Department of Planning and Zoning

TO: Development Review Board
FROM: Ken Lerner
DATE: April 1, 2014
RE: 14-0773CA/CU; 52 Locust Street

Request: Construct detached structure for an accessory unit, convert back porch to living space, add fencing, re-grade driveway.

52 Locust St # 053-4-018

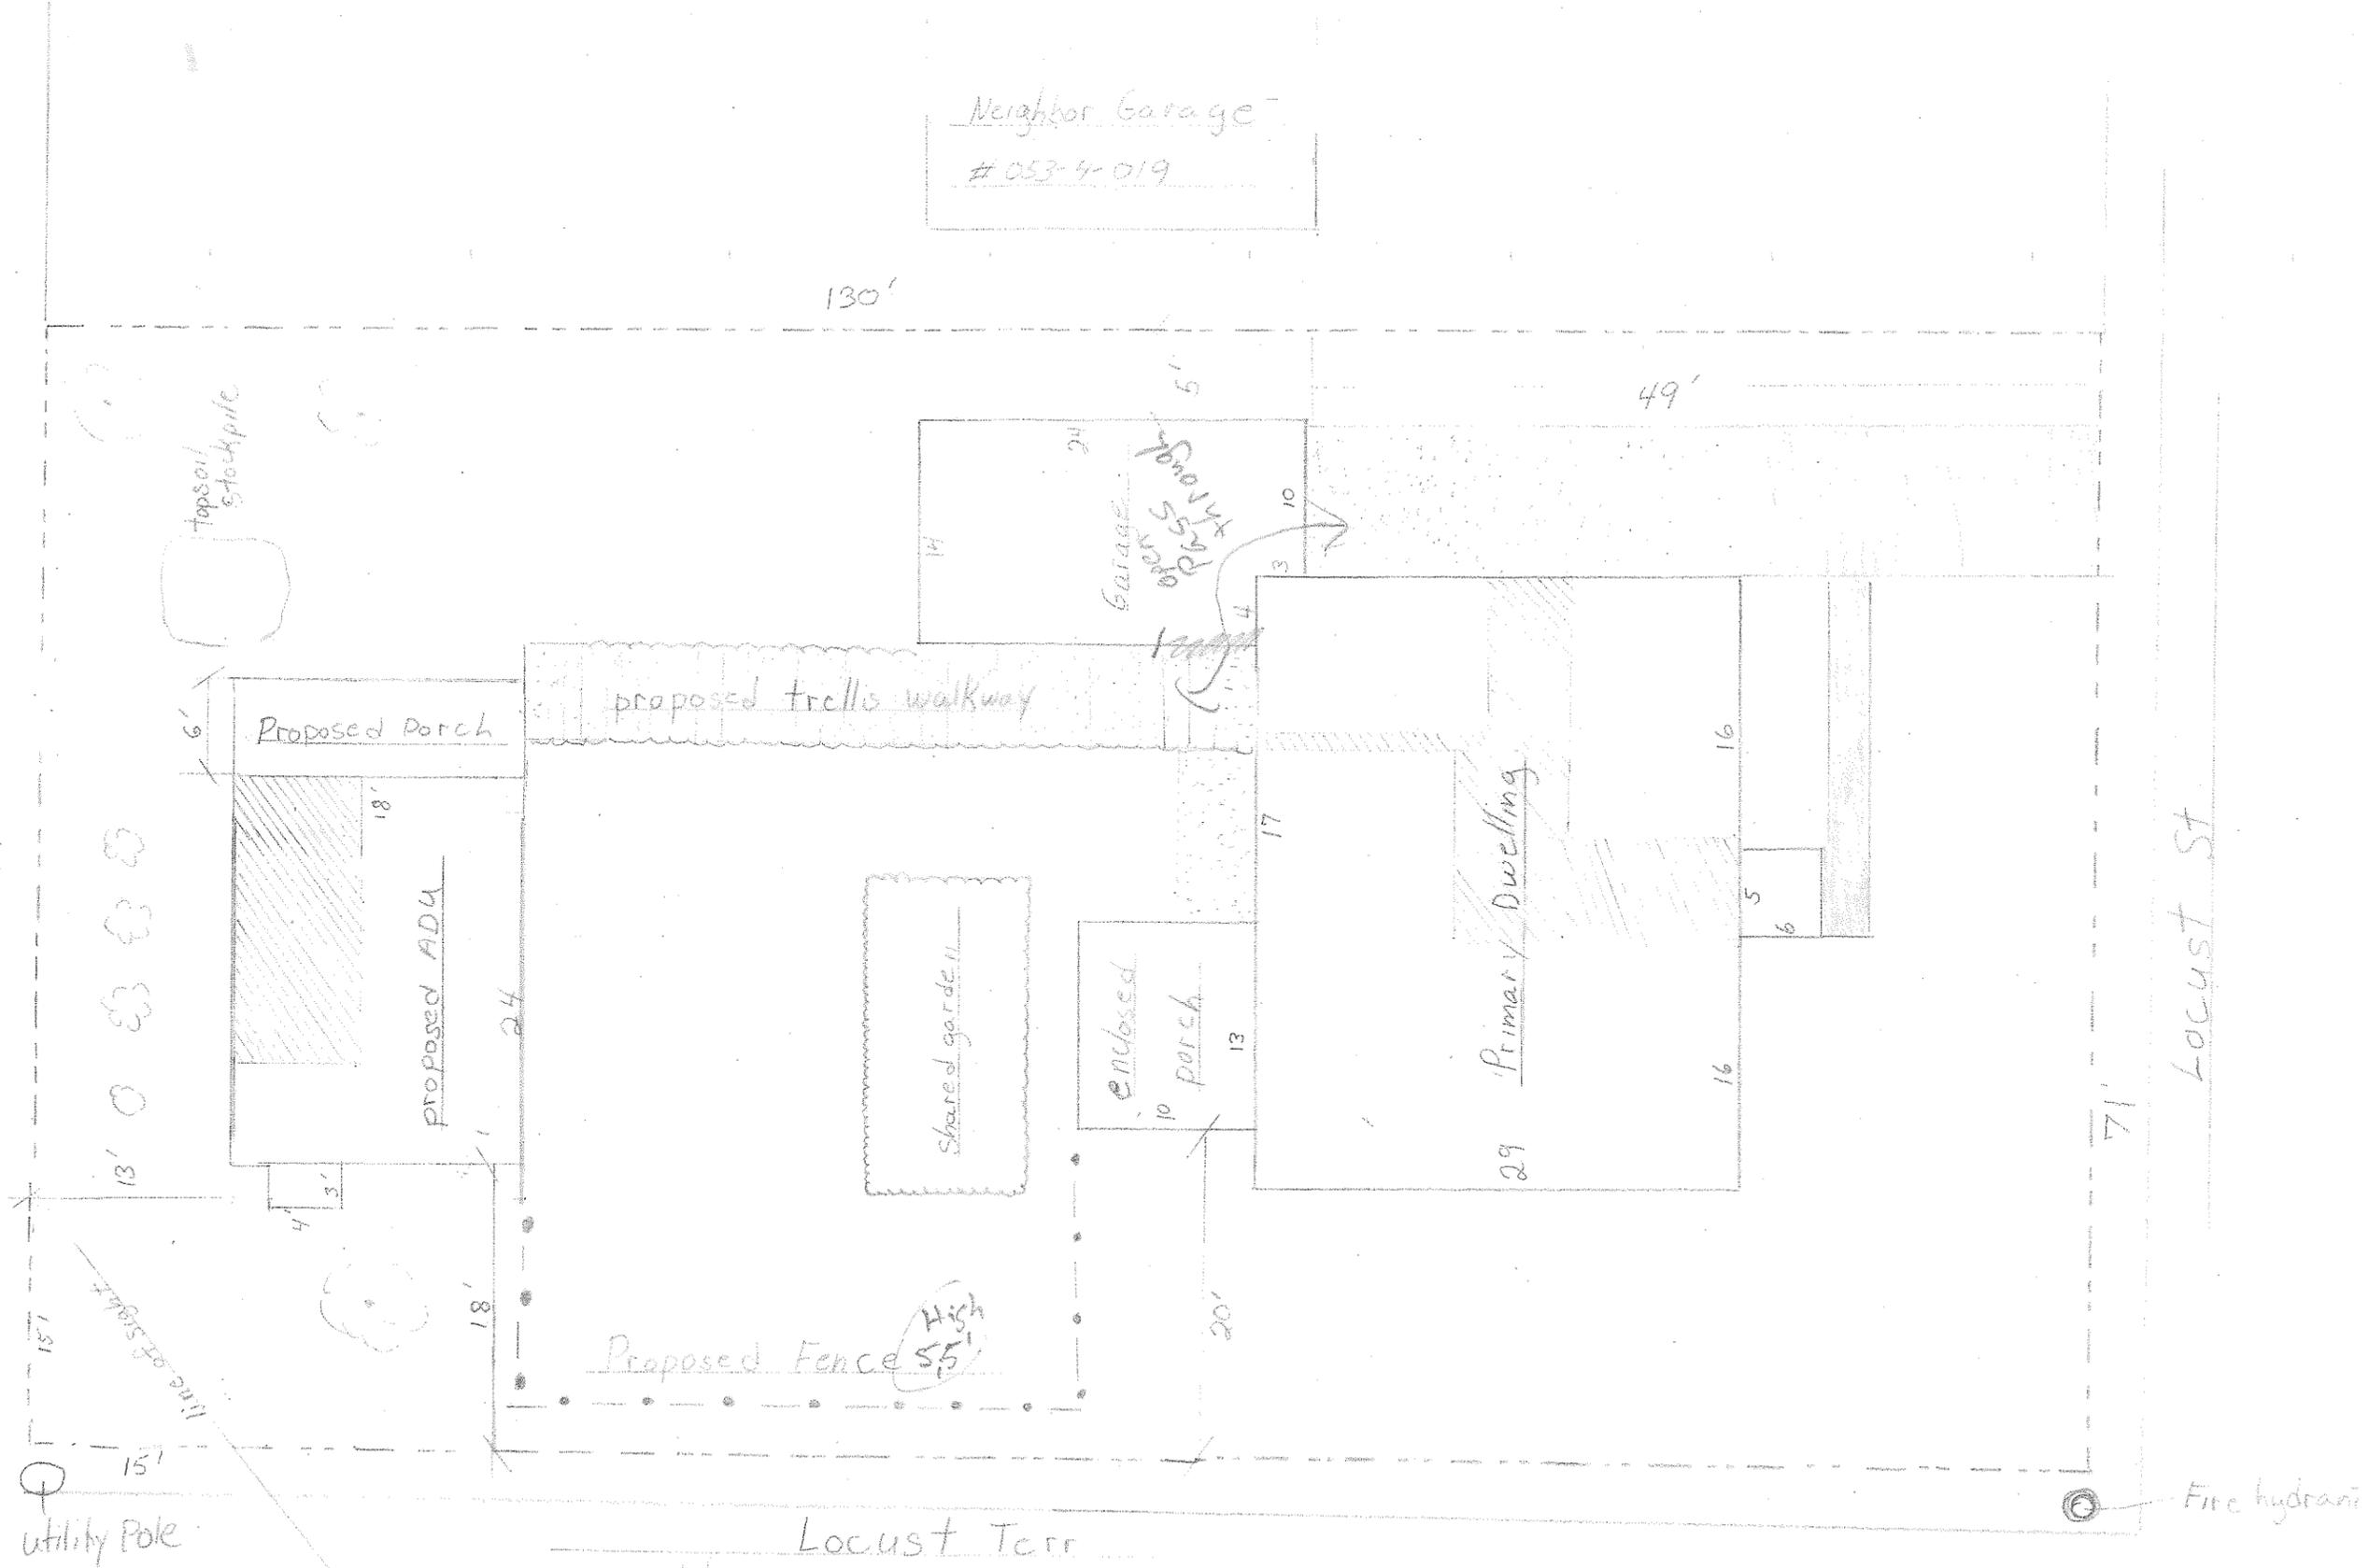
The accessory dwelling unit, being below 15 ft. tall when measured half way up the slope of the roof, is subject to a 5' side yard setback. As proposed, it will be set back 18.5' from the side boundary line. The proposed accessory dwelling unit needs to comply with the front yard setback; it appears that only a minor change may be necessary but that it could be met. The driveway is has two parking spaces in tandem, but while long enough cannot have three spaces stacked for the additional accessory unit.

4. *One additional parking space which may be legally allocated to the accessory unit must be in existence and provided for the accessory unit.*
There are two parking spaces in tandem in the existing driveway/garage on the property. Three parking spaces are required; two for the single family use and one for the accessory apartment. The driveway and garage are not sufficient to contain the required three parking spaces. **(Adverse finding)**

The accessory dwelling unit requires one parking space and the principal residence requires two spaces for a total of three. The driveway/garage is inadequate to contain the required parking.

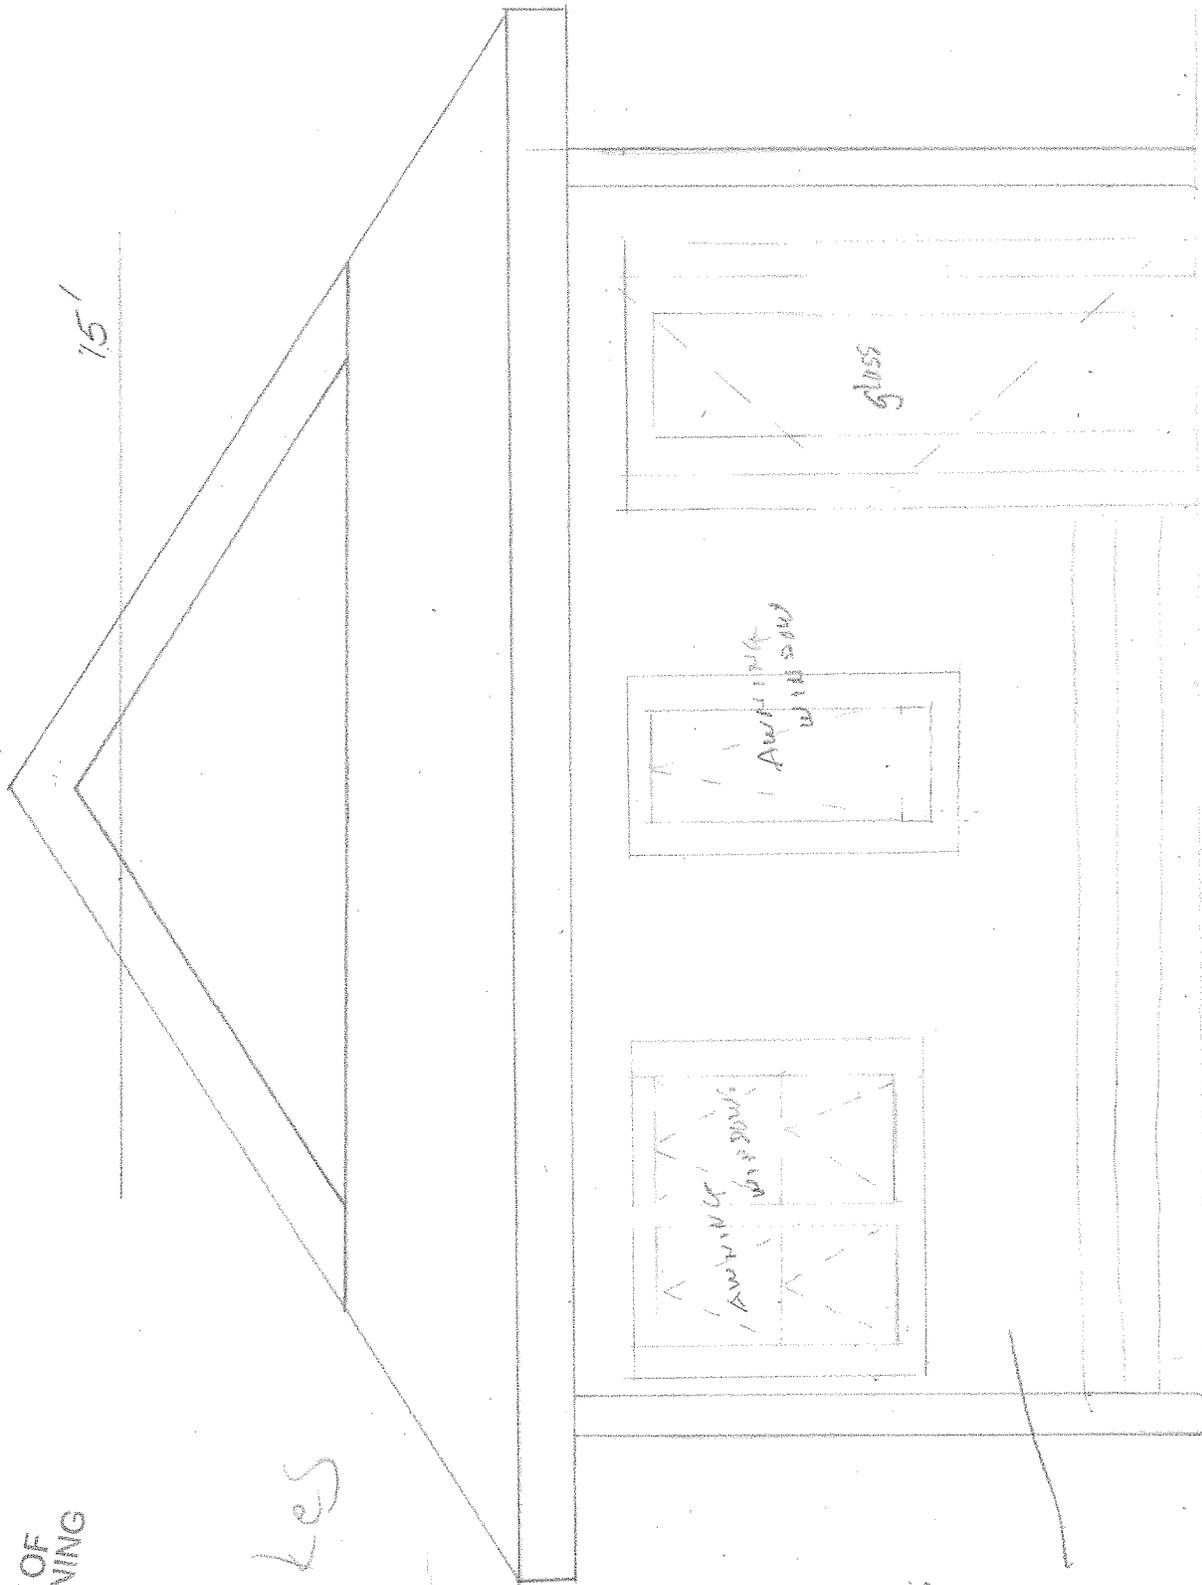
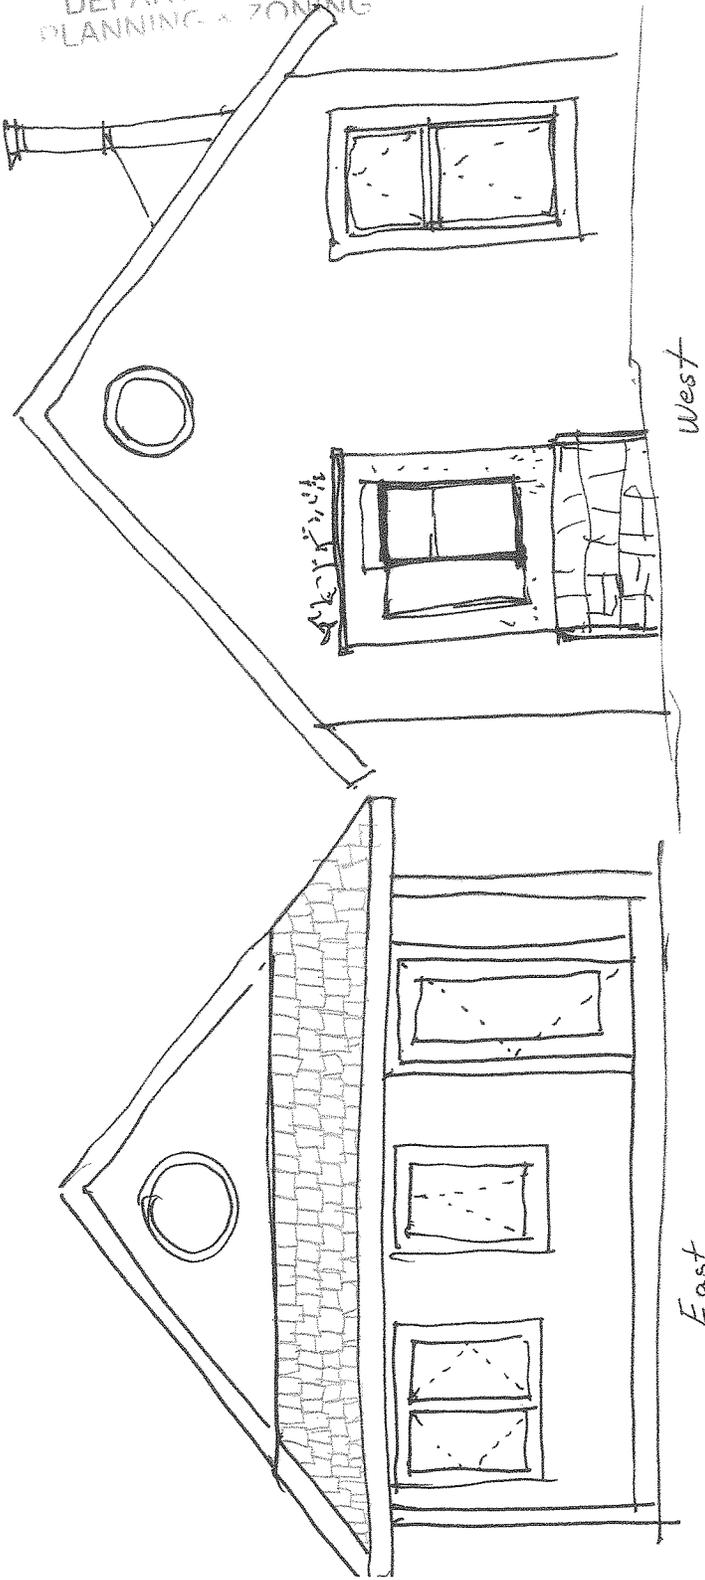
The submitted building elevations for the accessory unit indicates the height lower than 15' measured half way up the slope of the roof. This is below the 35' maximum height limit and thus no exceptions are sought. **(Affirmative finding)**

The proposed gable roof on the accessory dwelling appears similarly pitched as the primary residence roof. **(Affirmative finding)**

The proposed building will be clad in wood ship-lap siding. With awning windows and a glass front door proposed. The roofing material is proposed to be cedar shakes. The materials are of acceptable quality. **(Affirmative finding)**
